Wyoming Refining Company

Thank you for the opportunity to review DEQ's draft statement of basis and permit renewal for Wyoming Refining Company's ("WRC") Wyoming Pollutant Discharge Elimination System (WYPDES) permit number WY0001163 for the Newcastle Refinery. WRC timely applied for renewal of the permit on January 24, 2023 by submitting the required renewal application and supplemental information. DEQ's timely processing of the permit renewal is greatly appreciated, and WRC looks forward to working with DEQ to ensure the permit is appropriate for the Newcastle Refinery and compliant with all legal requirements.

WRC Stormwater Improvements

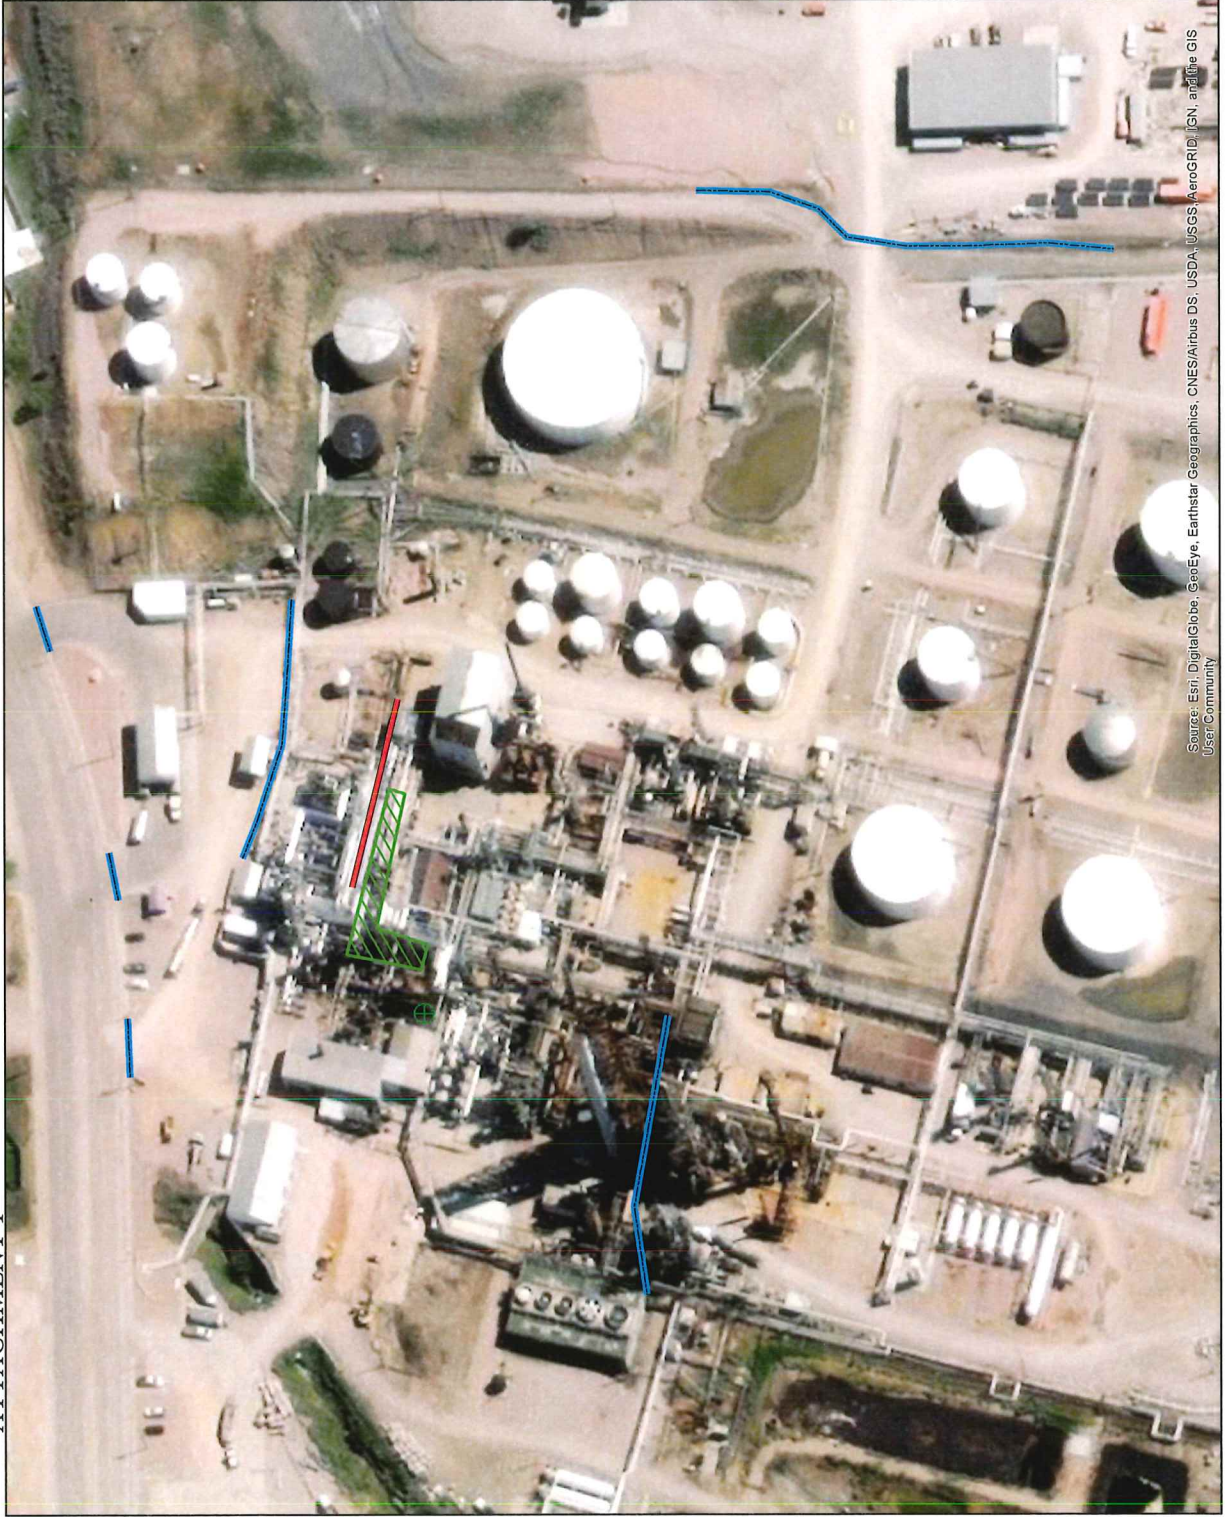
Improvement Status as of 2024:

- * Rollover curbing on three main street entries is completed.
- * Berm and ditch system west of environmental office and warehouse constructed. Stormwater directed to Pond 5

- * Berm along fence and gate near the main loading rack is constructed.
- * A 4" line with inlet that fed into the sewer system was discovered. A slide gate was installed to prevent flow during a storm event, but still enabled drainage during times of washdown.

- * A retaining wall was constructed in the crude unit to hold back stormwater from entering the refinery sewer systems from the north.
- * Curbing has been placed around several sewer inlets leaving small openings to allow for flow during washdown. This should significantly reduce flow rates into the sewer system during periods of stormwater runoff.

- * Flow from the two lift station pumps will now be run in separate pipes which should increase pumping rates. It is believed the existing system with a single line resulted in the two pumps working against each other.
